Transmittal
Submittal Review Response

Re: **Project No.:** 253117-261237
Project Name: PSTA Clearwater Multimodal Transit Center
Client: Pinellas Suncoast Transit Authority

Submittal No.: **S-051200-002-F**
Title or Description: **Structural Steel Framing Canopy & Pavilion**
Type of Submittal: **Shop Drawing** **If other**
Status
Review Code: Code 4: Approved As Noted; Resubmit
Other:
Review Comments:

1 E103 ELEVATION VIEW
(REF: 3/S-PB-3)
(OTHERS NOT SHOWN FOR CLARITY)

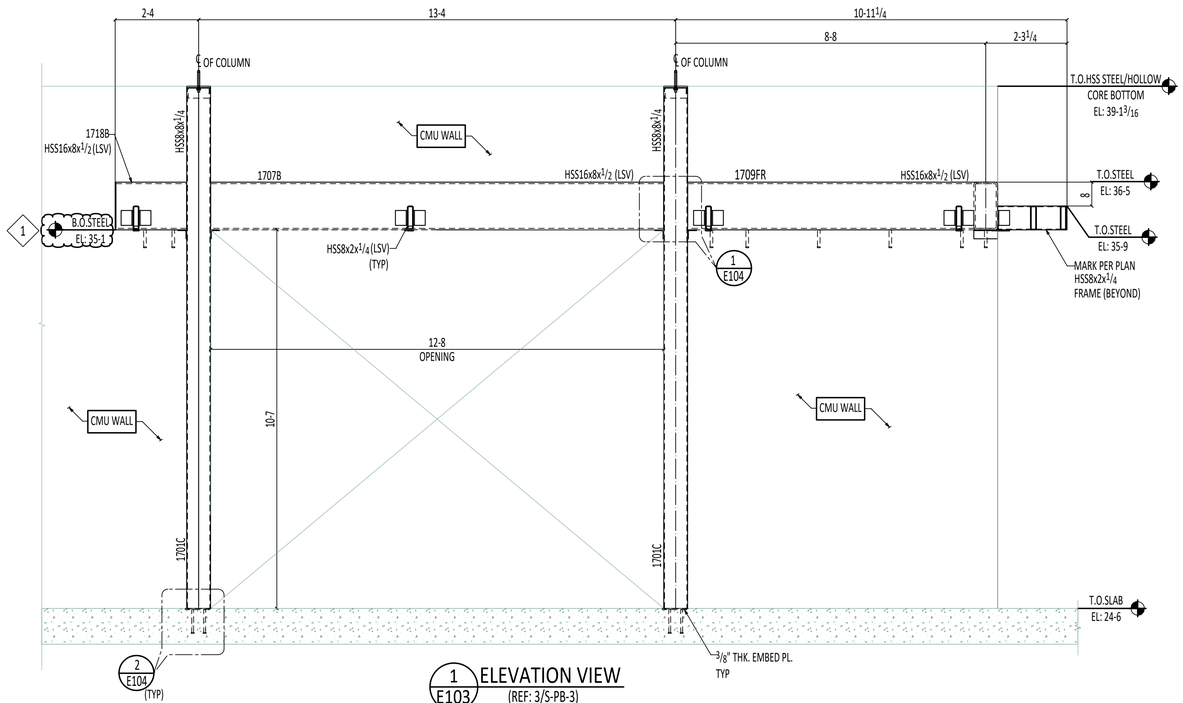
4. Contractor to confirm steel elevation on p. 6 of 231 with approved storefront (not yet submitted). Engineer confirms intent is met. This is a repeat comment and Contractor has indicated coordination to still be completed.

1 -GC TO CONFIRM THE BOTTOM OF STEEL ELEVATION WITH STOREFRONT & CONCRETE CURB MANUFACTURER.

PARTIAL ROOF FRAMING PLAN

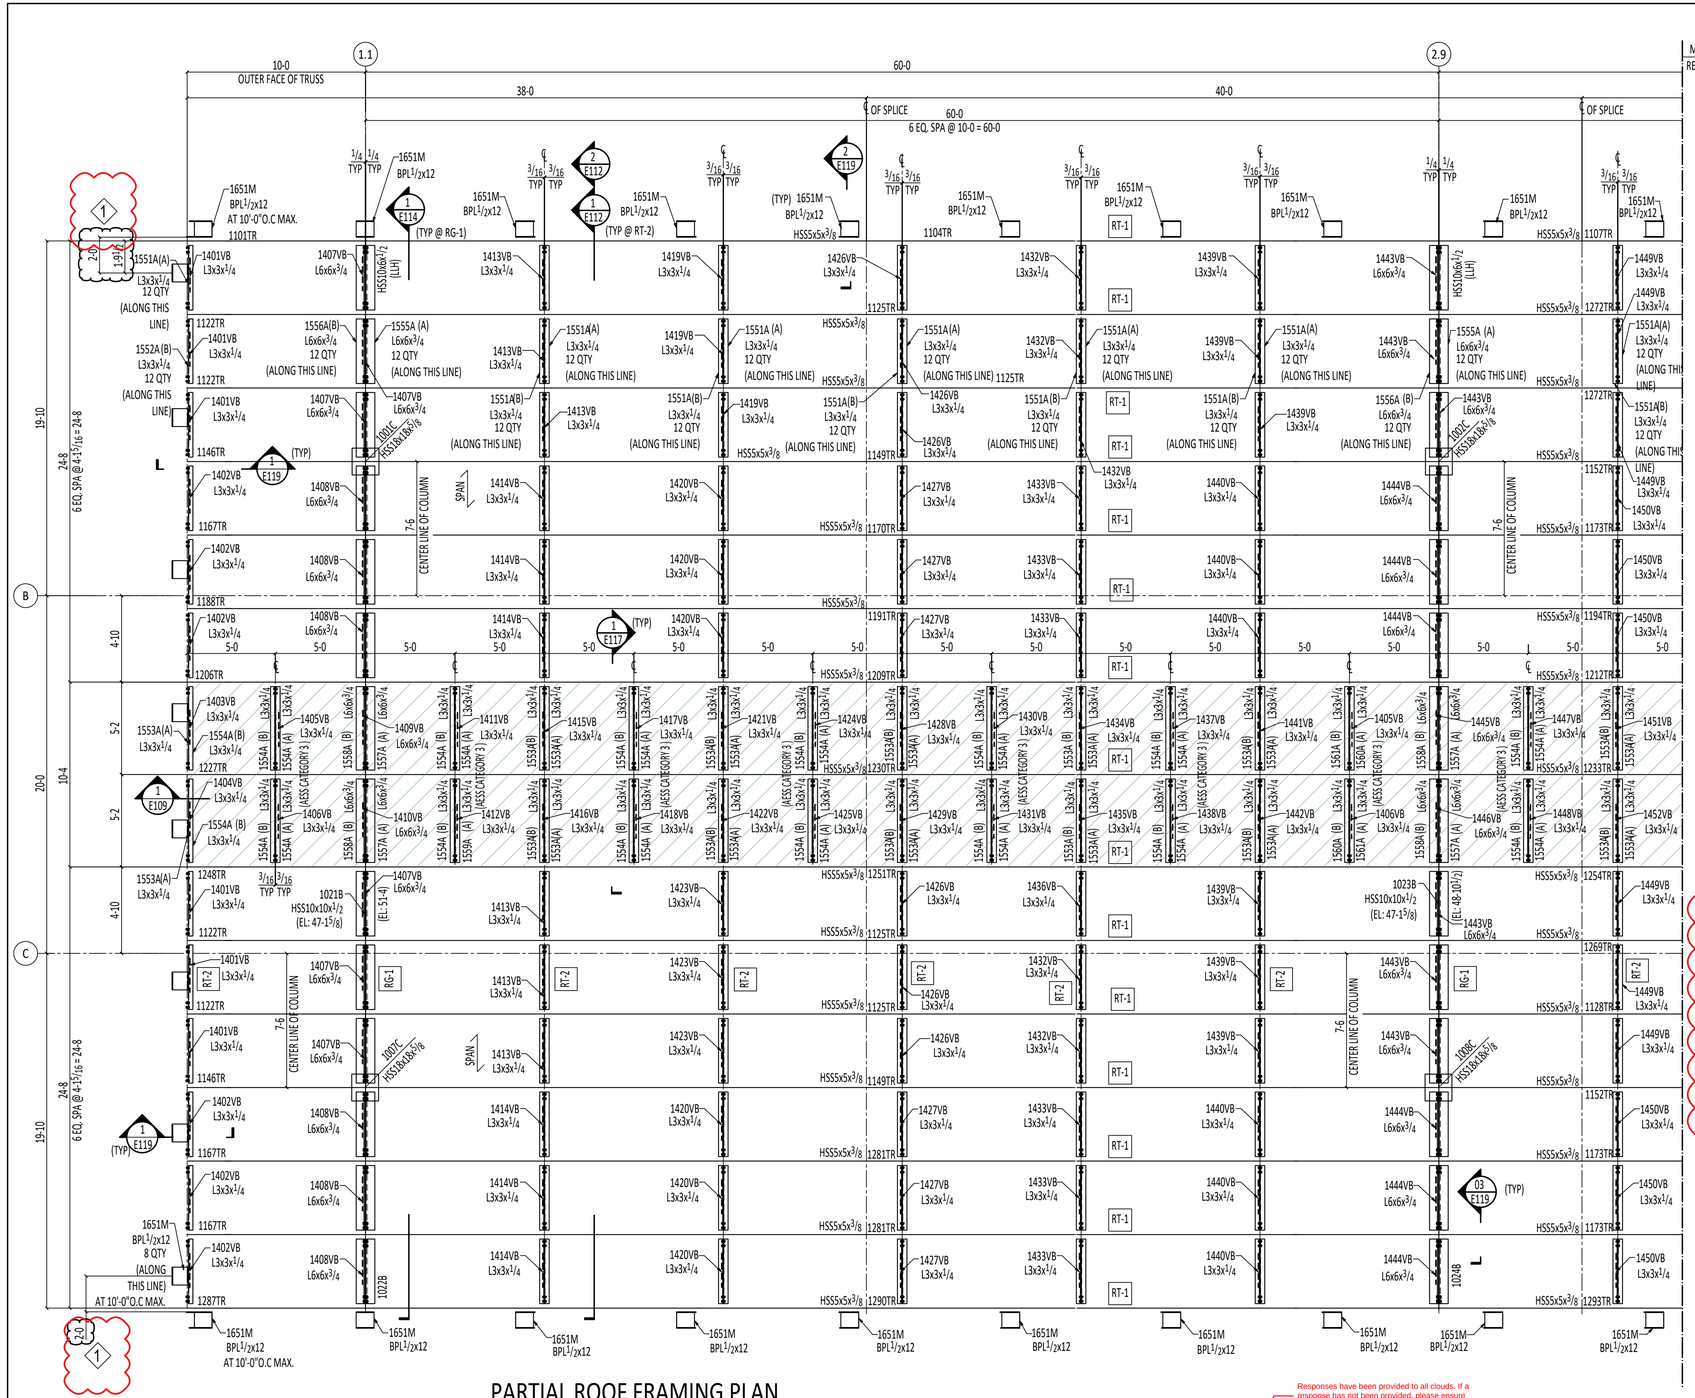
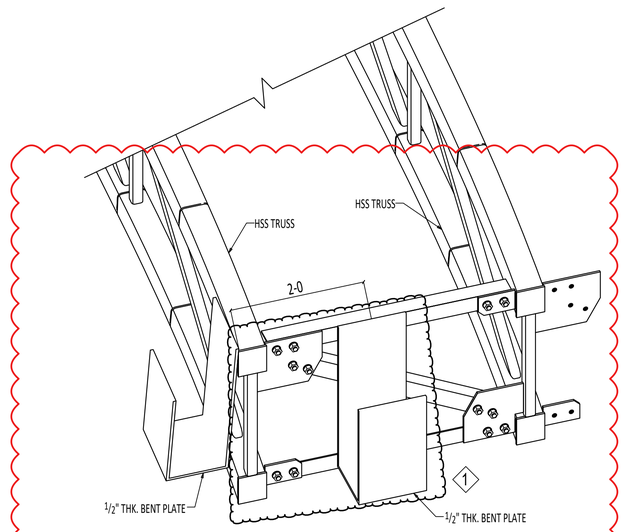
28. Receipt acknowledge od drawing E121 Wave Canopy roof hatch. However, hatch location is not shown on E106 partial roof framing of wave canopy. Contractor to locate and properly adjust roof hatch on E106.

1 E110 ROOF TRUSS ELEVATION VIEW-1 (RT-1)

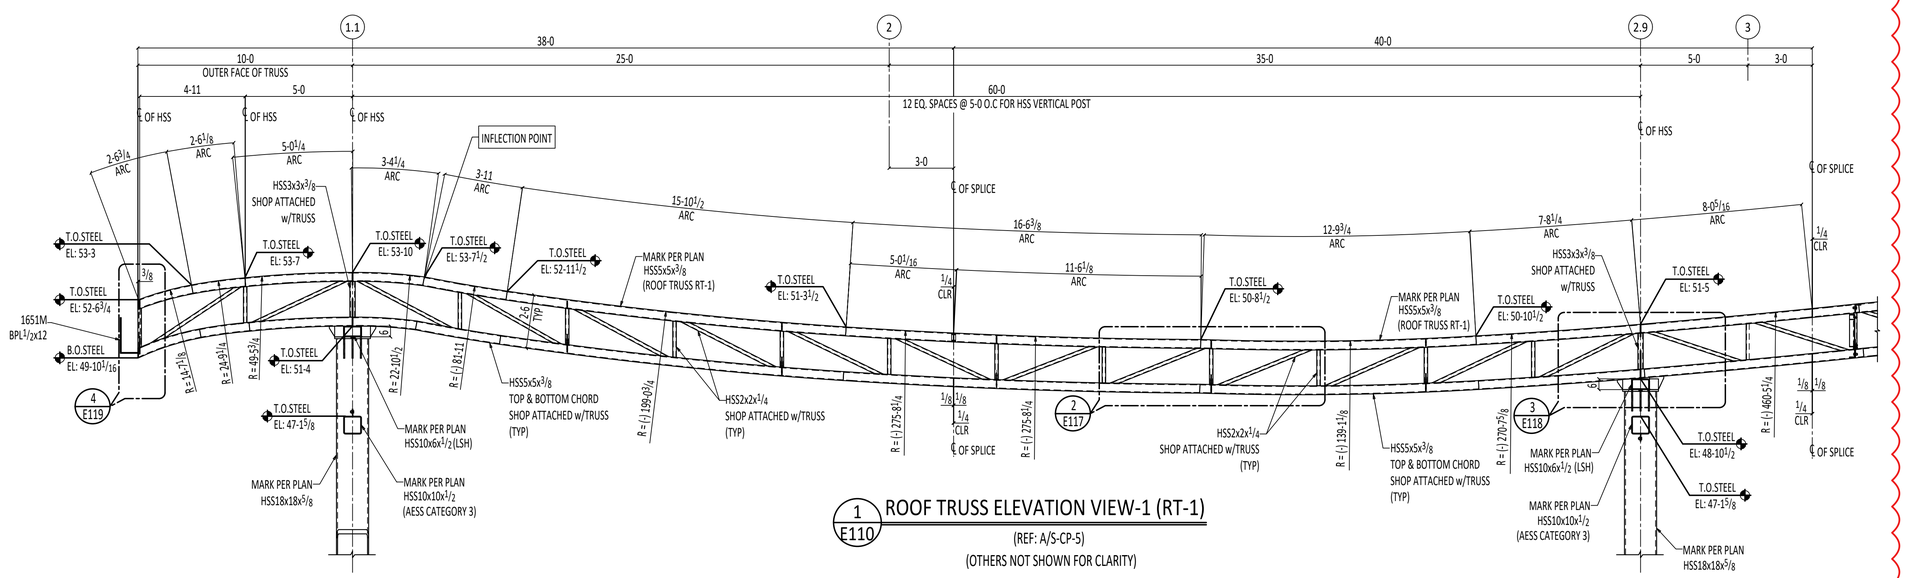
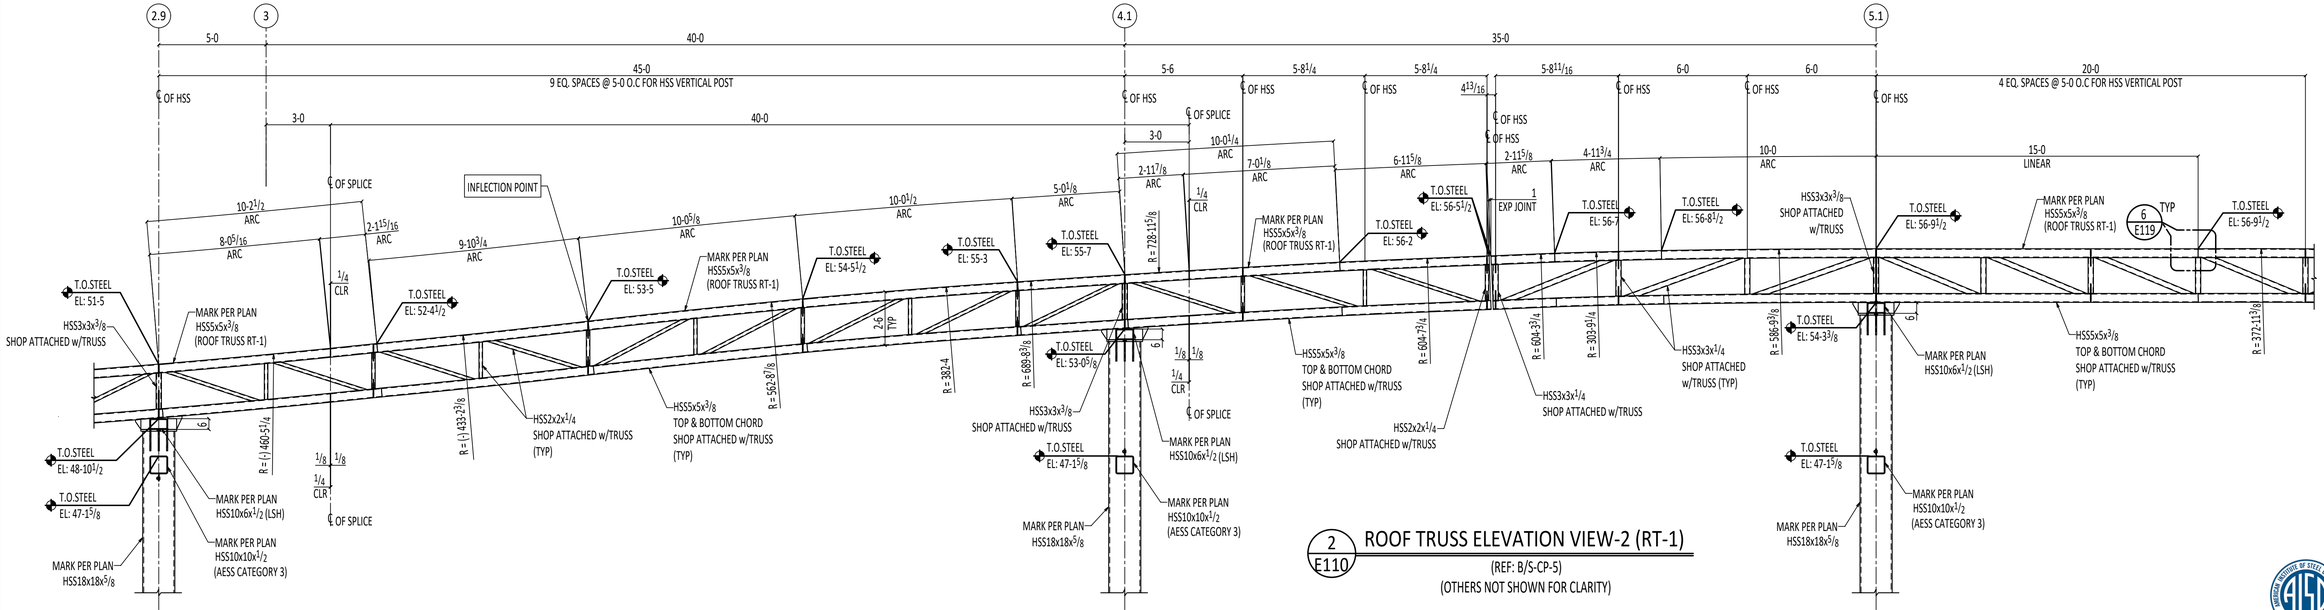
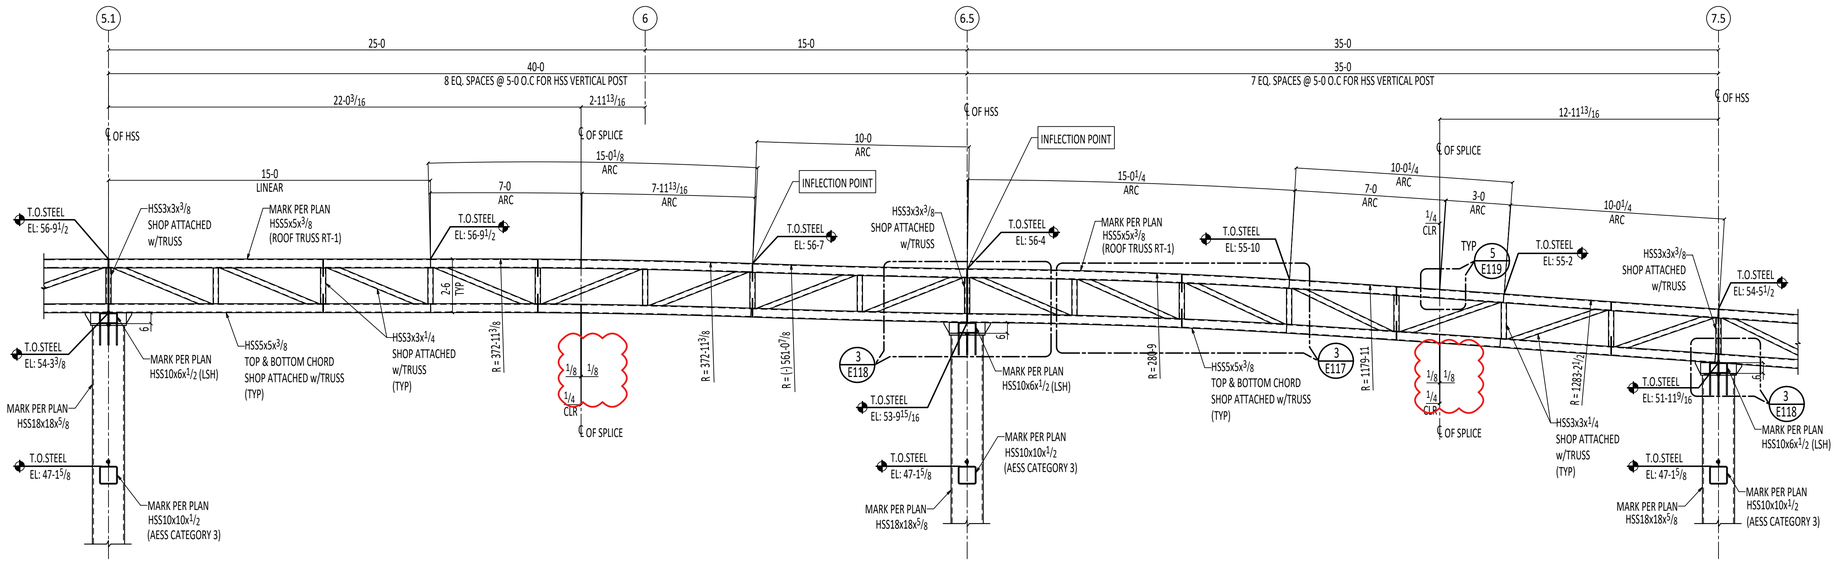
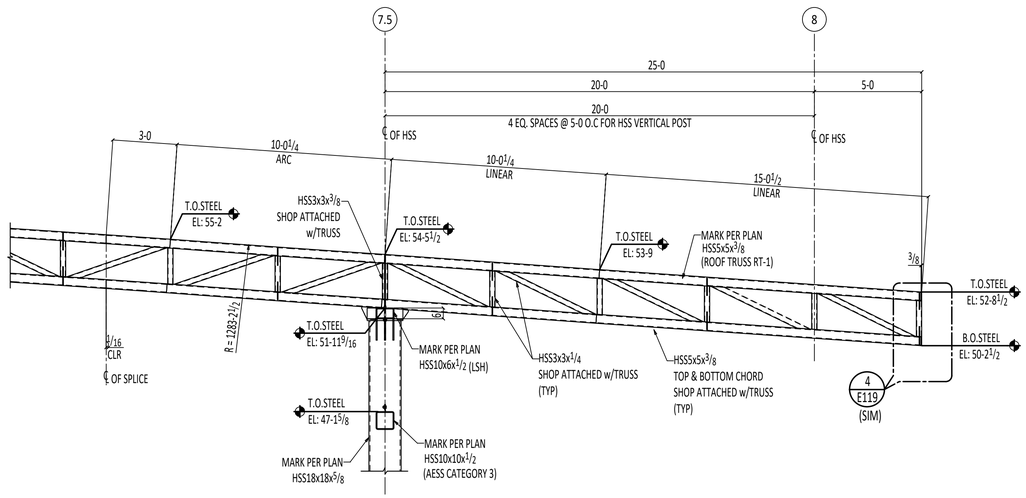
5. There is a mismatch between the dimensions and wave truss bend radii shown on the overall truss longitudinal drawings, E110 and E111, and those shown on the contract drawings and typical truss shop drawings, Drawing Nos. 1176 through 1200. Coordinate between the drawings and ensure that

all dimensions and bend radii are consistent with and accurately reflect the requirements shown on the contract drawings.

1 E118 TYPICAL RT-2 & RT-3 TRUSS CONNECTION ARRANGEMENT

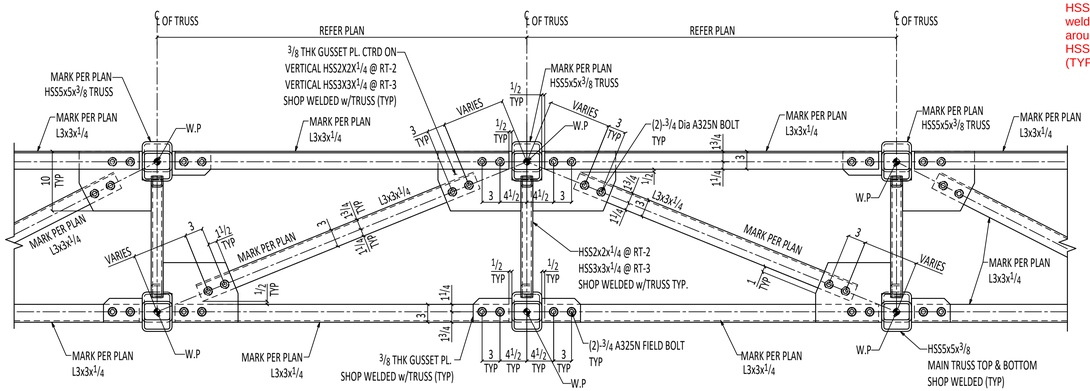
HSS3X3X3/8 TO HSS5X5X3/8 Connection weld information is missing. Provide 5/16" all around fillet weld to connect HSS3x3x3/8 to HSS5x5x3/8 as shown in detail B/S-CP-8 (TYP at all the wave canopy grid locations)

2 E118 TYPICAL RG-1 TRUSS CONNECTION ARRANGEMENT

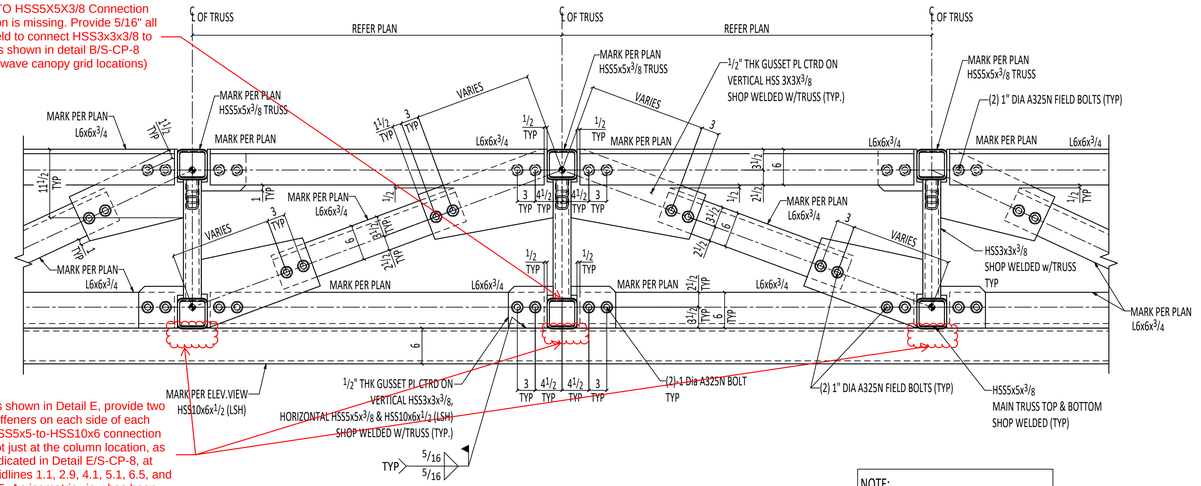
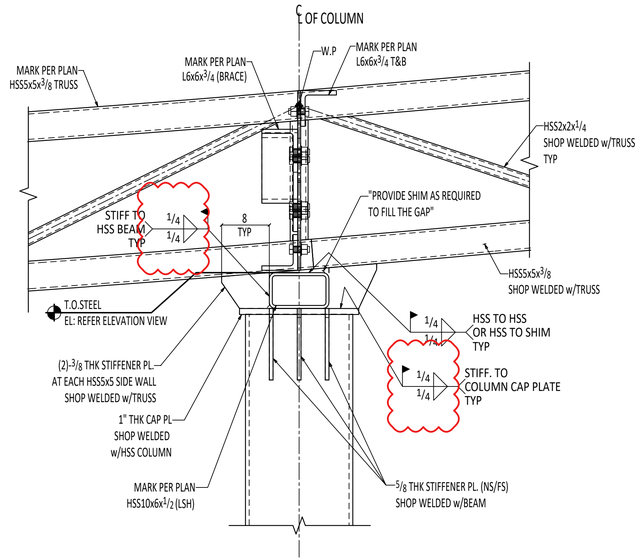
6. As shown in Detail E, provide two stiffeners on each side of each HSS5x5-to-HSS10x6 connection not just at the column location, as indicated in Detail E/S-CP-8, at gridlines 1.1, 2.9, 4.1, 5.1, 6.5, and 7.5. An isometric view has been provided for clarity on E118. This is a repeat comment (previously only a pdf markup).

As shown in Detail E, provide two stiffeners on each side of each HSS5x5-to-HSS10x6 connection not just at the column location, as indicated in Detail E/S-CP-8, at gridlines 1.1, 2.9, 4.1, 5.1, 6.5, and 7.5. An isometric view has been provided for clarity

ROOF OPENING PLAN AT WAVE CANOPY

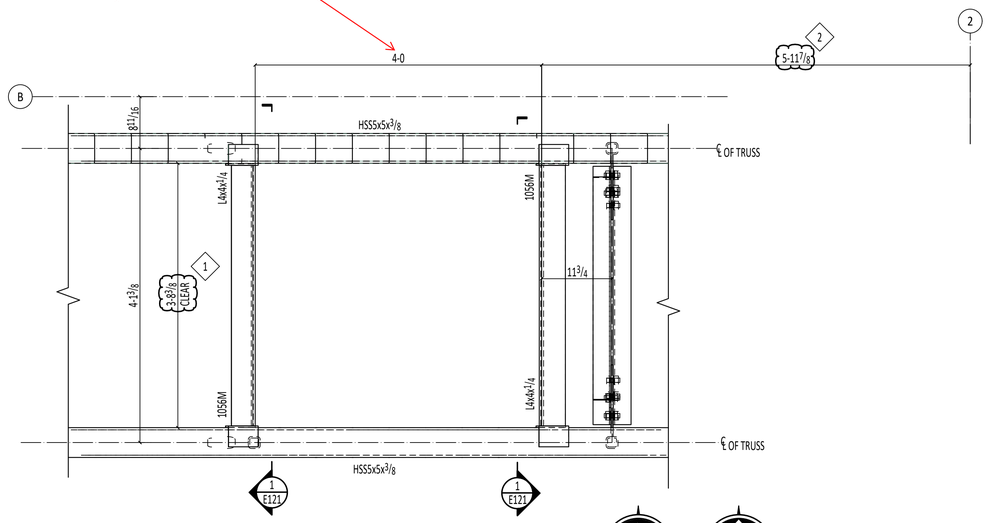
Access hatch clear dimensions shall be coordinated with the approved hatch submittal and location on architectural drawings

1 -WHEN FOLLOWING THE TRUSS SPACING PER CD, WE GOT THE CLEAR DIMENSION AS SHOWN SINCE ARCH DRAWING SHOWS 4'-0" OPENING.PLEASE CONFIRM WITH ROOF HATCH MANUFACTURER.

ROOF HATCH LADDER PLAN AT WAITING PAVILION BUILDING

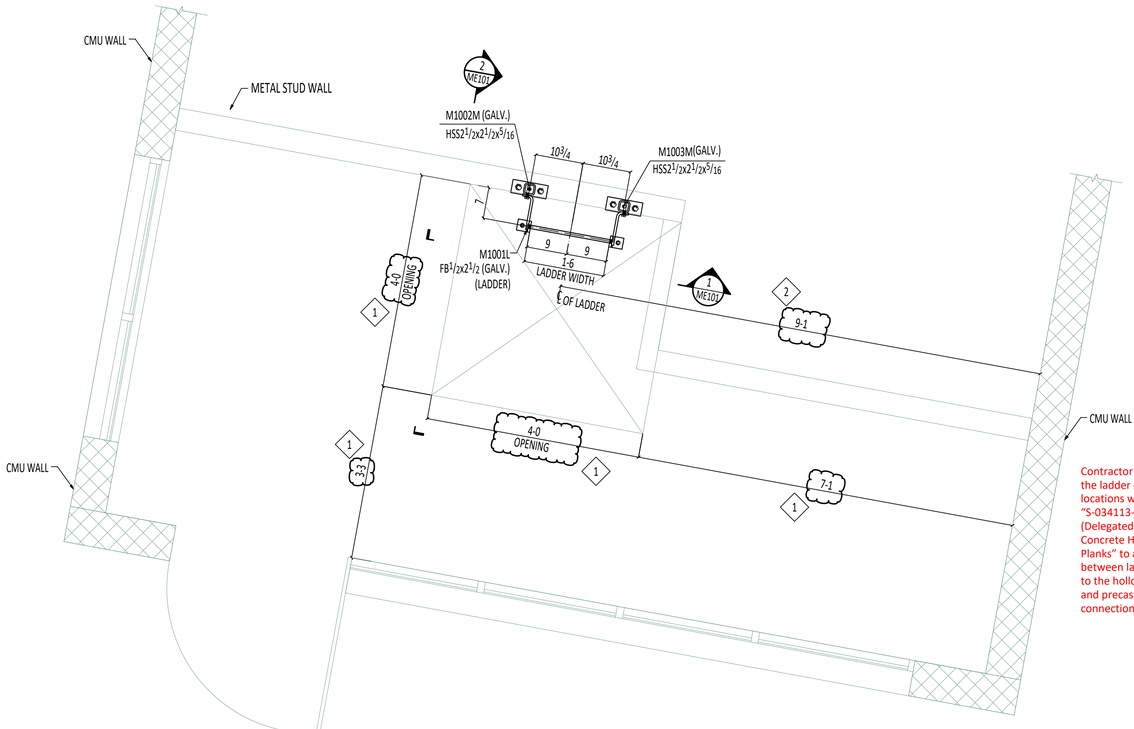
23. Contractor shall coordinate ladder connection locations with submittal “S-034113-001-A – (Delegated Design) Precast Concrete Hollow Core Planks” to avoid conflicts between ladder

connections to hollow core planks and precast panel embed connections at openings at the retail/operations and waiting pavilion buildings. This is a repeat comment as coordination has not been provided and conflicts may exist.

Contractor shall coordinate the ladder connection locations with submittal "S-034113-001-A – (Delegated Design) Precast Concrete Hollow Core Planks" to avoid conflicts between ladder connections to the hollow core planks and precast panel embed connections at openings.

21. Ladder / hollow-core coordination
Revised ladder connection details are shown. Final connection locations will be coordinated with the approved hollow-core layout before installation; follow-up will be submitted if required.
